March 31, 1982
AW-82-21

APPLICATION FOR WITHHOLDING PROPRIETARY
INFORMATION FROM PUBLIC DISCLOSURE

SUBJECT: Response to Questions on WCAP-9561, "Bart-A1: A Computer Code for the Best Estimate Analysis of Reflood Transients" (Proprietary)

RUN 3233 SURFACE TEMPERATURE
48 INCH GROUP=1.00
MEAN + AND - STANDARD DEVIATION

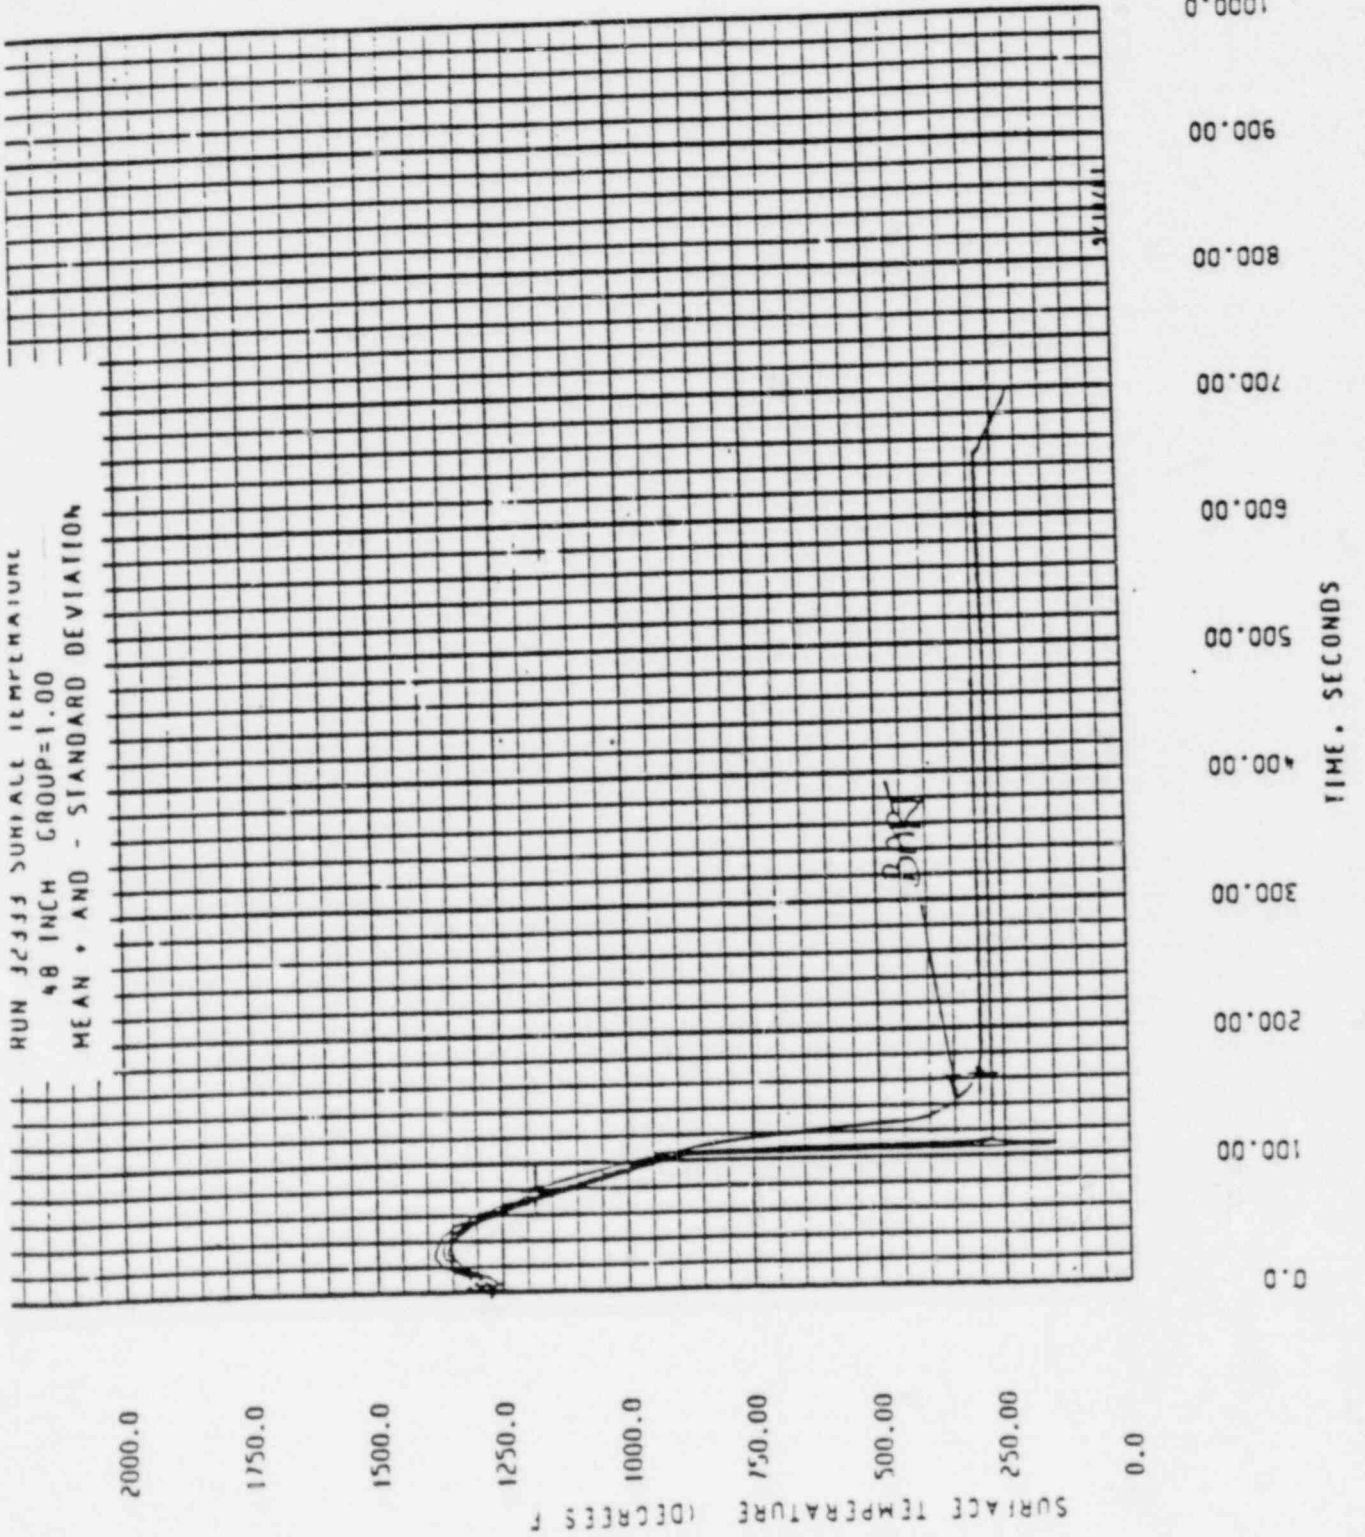
- 4.) Provide comparison calculations of the PWR FLECHT SEASET unblocked bundle, forced and gravity reflood tests 32333 and 32234. These comparisons should include but are not restricted to calculations modelling rod 6L in test 32333 and 6K in test 32235; also rods 7J, 8K, 9K and 11E for both tests. Include the input data in the calculations summary.

Table 1 lists the initial and boundary conditions for tests 32333 and 32235. Figure 1 shows the noding scheme, power profile, and initial temperature profile used in the BART calculation. Figures 2 - 5 compare BART predicted clad temperatures to the measured temperature of the rods listed above for test 32333 wherever these measurements are available. A more representative comparison is shown in Figures 6 - 9, where the BART prediction is compared to the mean temperature of all rods more than two rows away from the test housing and dead rods. Similar comparisons are shown in Figures 10 - 13 and 14 - 17 for test 32235. It can be seen that agreement is quite good for these stepped flooding rate tests.

Figure 2 Control Volume Used to Calculate Fluid Conditions Near Quench Front

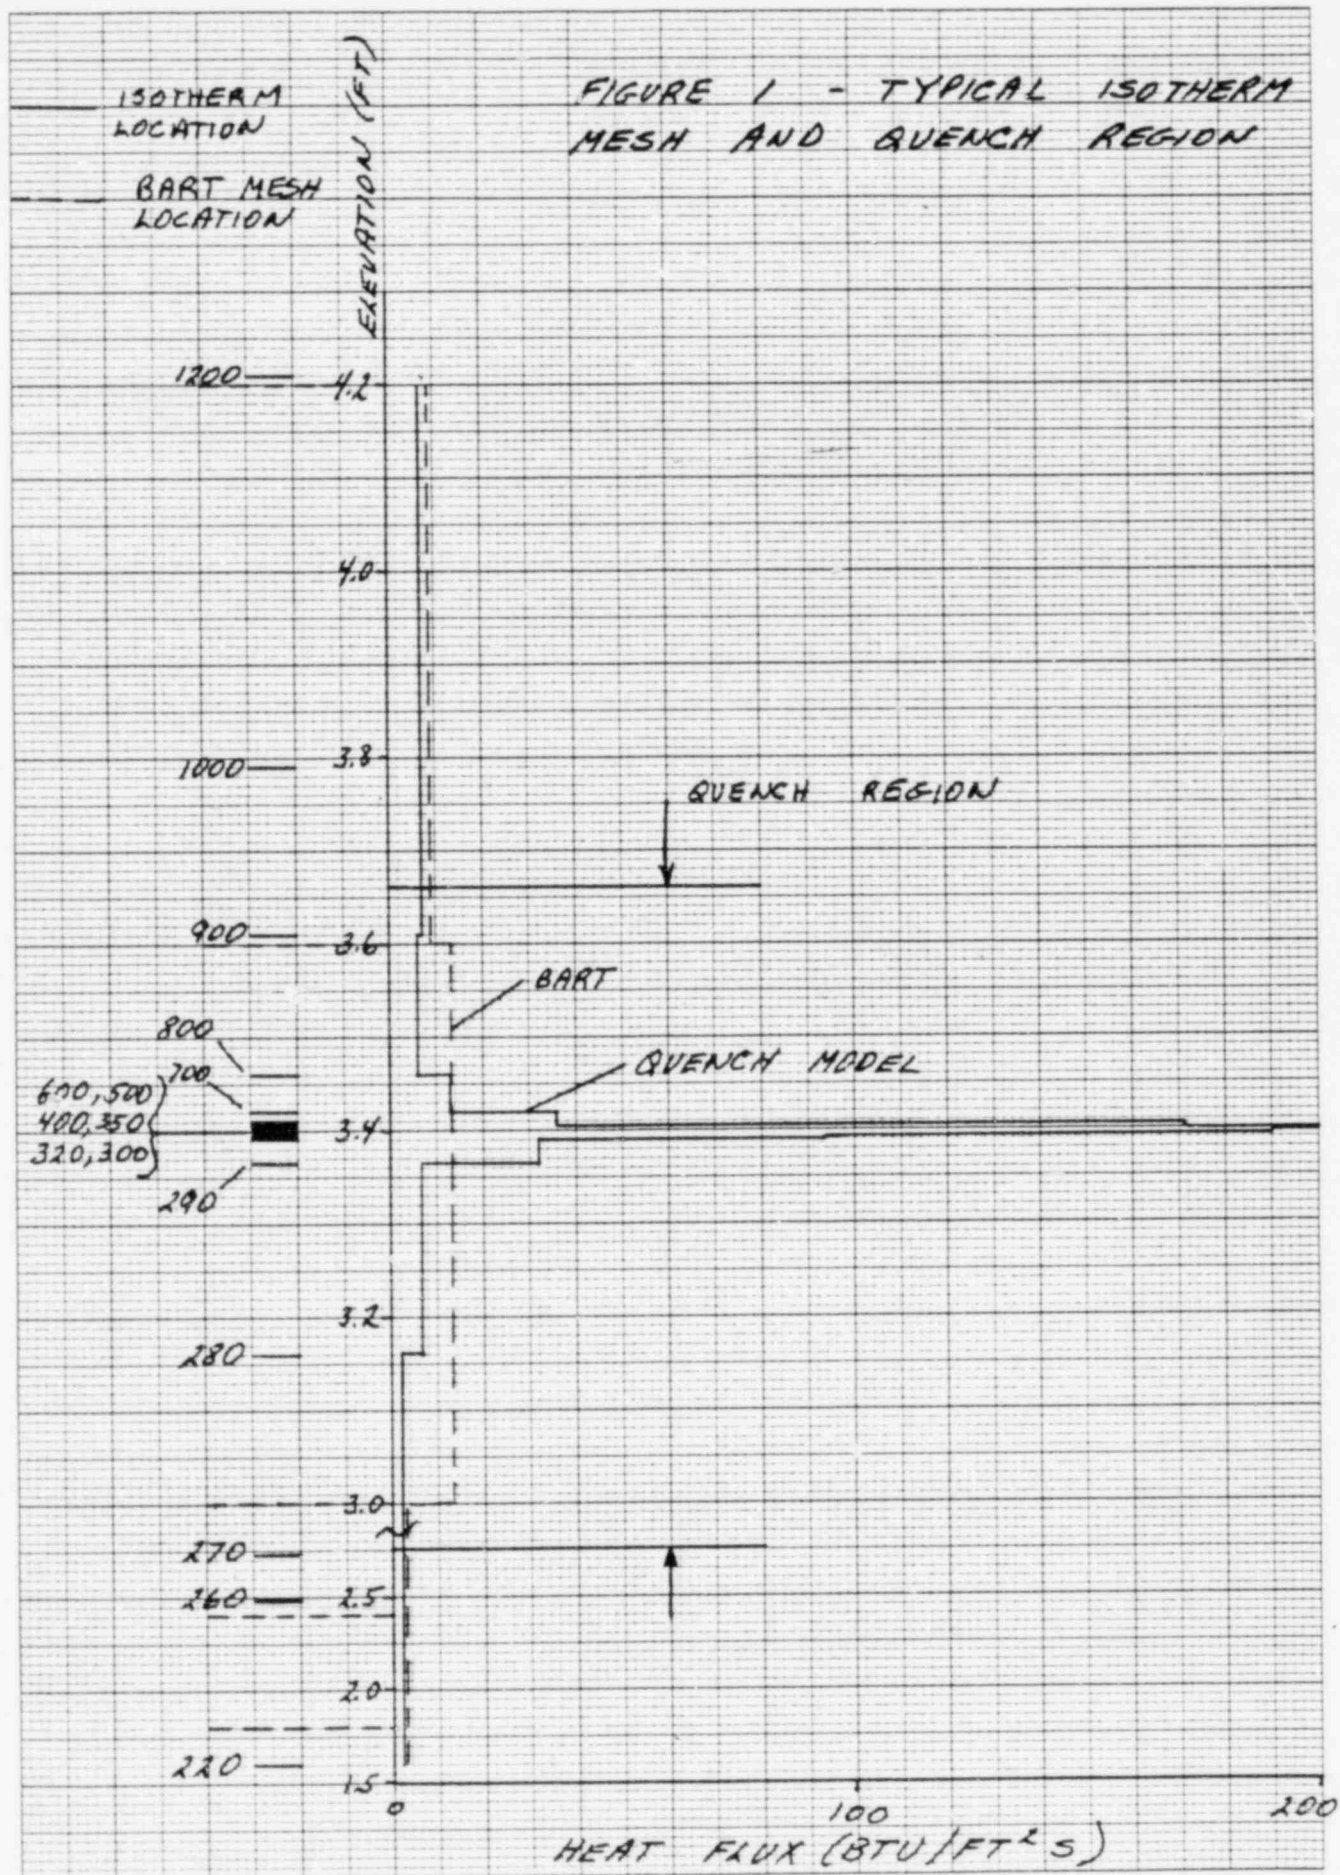
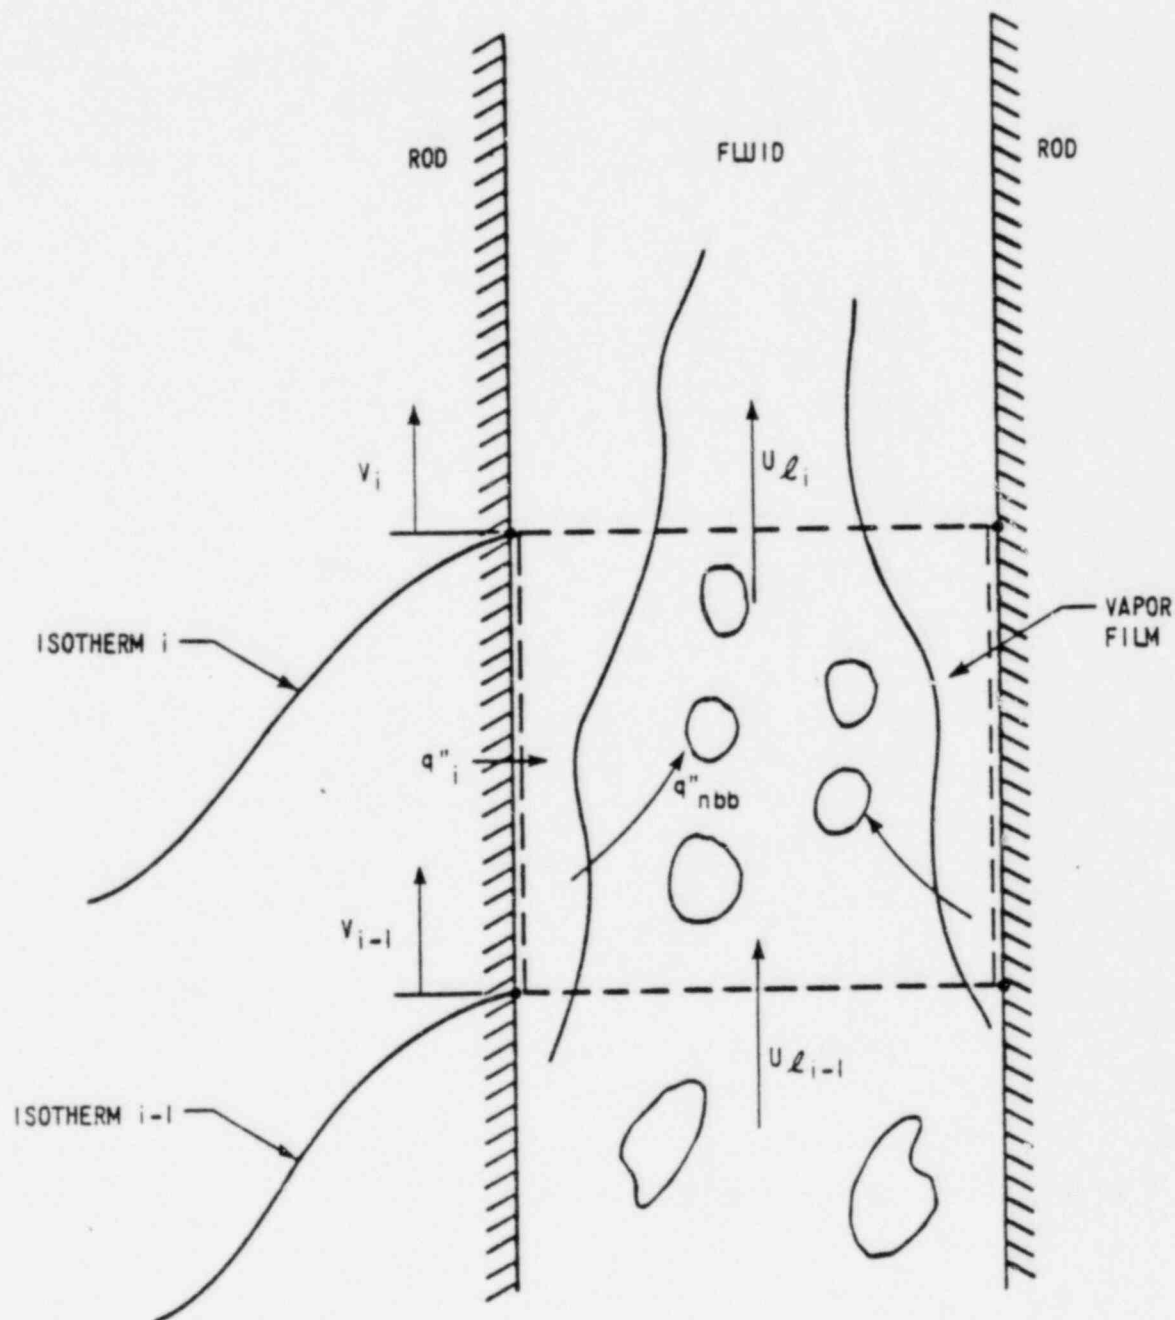
- 1) The thermal and hydraulic modeling is referred to as "near the quench front." Quantify this statement.

- 6) Is it not clear that the heat fluxes of 3.3-39 function over the same areas. Do forced convection and nuclear boiling occur over the same surface? If so, how?

Figure 1 illustrates a typical isotherm mesh and the region within which detailed calculations are made.

The forced convection component of q''_i , is assumed to generate vapor which is released in the form of bubbles and is then recondensed, as is illustrated in figure 2. Although the bubbles released into the fluid shrink as they recondense, new bubbles are continually being formed. It is therefore reasonable to use a mean bubble size (eq. 3.3-34) in calculating the condensation rate.
